Submit 1 Copy To Appropriate District Office			EMNRD-OCD ARTESIA Form C-103 REC'D: 05/06/2020 Revised July 18, 2013
<u>District I</u> – (575) 393-6161 1625 N. French Dr., Hobbs, NM 88240	Energy, Minerals and Natural Resources		WELL API NO.
<u>District II</u> – (575) 748-1283 811 S. First St., Artesia, NM 88210	OIL CONSERVATION DIVISION		30-005-62829 5. Indicate Type of Lease
<u>District III</u> – (505) 334-6178 1000 Rio Brazos Rd., Aztec, NM 87410	1220 South St. Francis Dr.		STATE FEE
<u>District IV</u> – (505) 476-3460 1220 S. St. Francis Dr., Santa Fe, NM 87505	Santa Fe, NM 87505		6. State Oil & Gas Lease No. LG-5246
SUNDRY NOTICES AND REPORTS ON WELLS (DO NOT USE THIS FORM FOR PROPOSALS TO DRILL OR TO DEEPEN OR PLUG BACK TO A DIFFERENT RESERVOIR. USE "APPLICATION FOR PERMIT" (FORM C-101) FOR SUCH			7. Lease Name or Unit Agreement Name Pathfinder AFT State
PROPOSALS.) 1. Type of Well: Oil Well	ALS.)		8. Well Number

2. Name of Operator	Gas well Guid Swb		9. OGRID Number
EOG Resources, Inc. 3. Address of Operator			7377 10. Pool name or Wildcat
104 South Fourth Street, Artesia, NM 88210		SWD; Fusselman

4. Well Location Unit Letter F : 2310 feet from the North line and 1850 feet f

12. 1" and back fill as needed. 13. Cut off wellhead and weld on dry hole marker. Clean location as per regulated.			
Wellbore schematics attached			
Spud Date:	Rig Release D	ate:

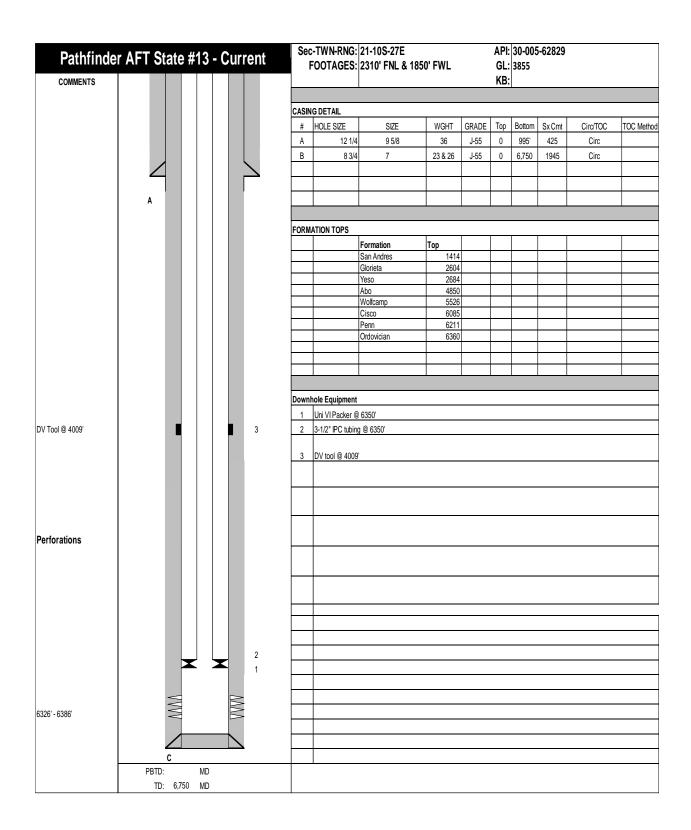
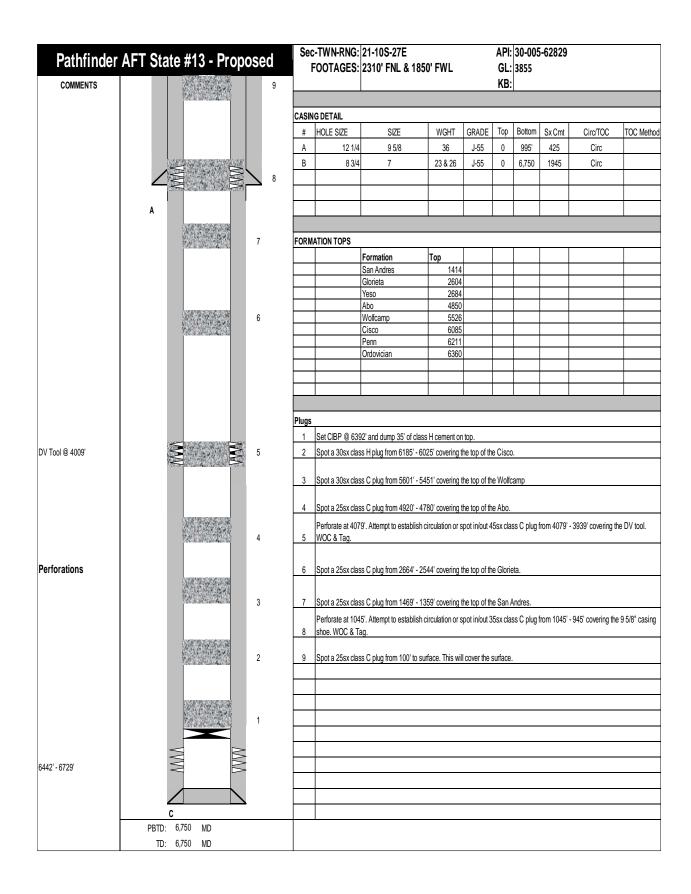
13. Describe proposed or completed operations. (Clearly state all pertinent details, and give pertinent dates, including estimated date of starting any proposed work). SEE RULE 19.15.7.14 NMAC. For Multiple Completions: Attach wellbore diagram of			
proposed completion or recompletion.			
EOG Resources, Inc. plans to plug and abandon this well as follows: Only Class "C" cement needed

**** SEE ATTACHED COA's**** MUST BE PLUGGED BY 5/7/2021			
I hereby certify that the information above is true and complete to the best of my knowledge and belief.			
SIGNATURE TINA HUE	rta titlei	Regulatory Special	ist DATEMay 6, 2020
Type or print name Tina Hue For State Use Only	erta E-mail address: ti	ina_huerta@eogre	sources.com PHONE: <u>575-748-4168</u>
APPROVED BY: <u>Gilbert</u> (Conditions of Approval (if any):	Cordero TITLE	Staff W	<i>IGR</i> DATE 5/7/2020
